Subject: Conditional Approval on Phase II Bond Release of 95.4 Acres of the Willow Creek Permit Area, C/007/0038, Task ID #4094

Willow Creek Mine
Plateau Mining Company
Technical Analysis
Phase II Bond Release, 95.4-Acres, Task ID #4094
July 2, 2012

Inspection Report

Figure - 6 Hike up Schoolhouse Canyon Refuse Pile Area.

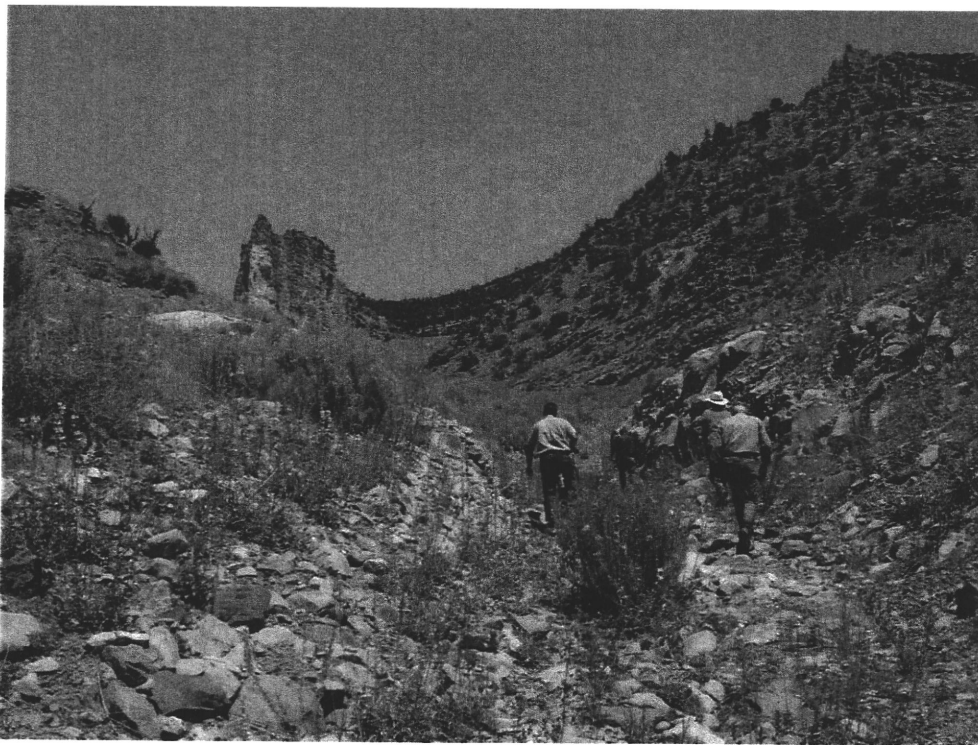
We hiked to the top of the Schoolhouse Canyon refuse pile. This site is well vegetated and appears to be stable. All of the refuse pile appears to have adequate cover with no signs of any refuse being exposed.
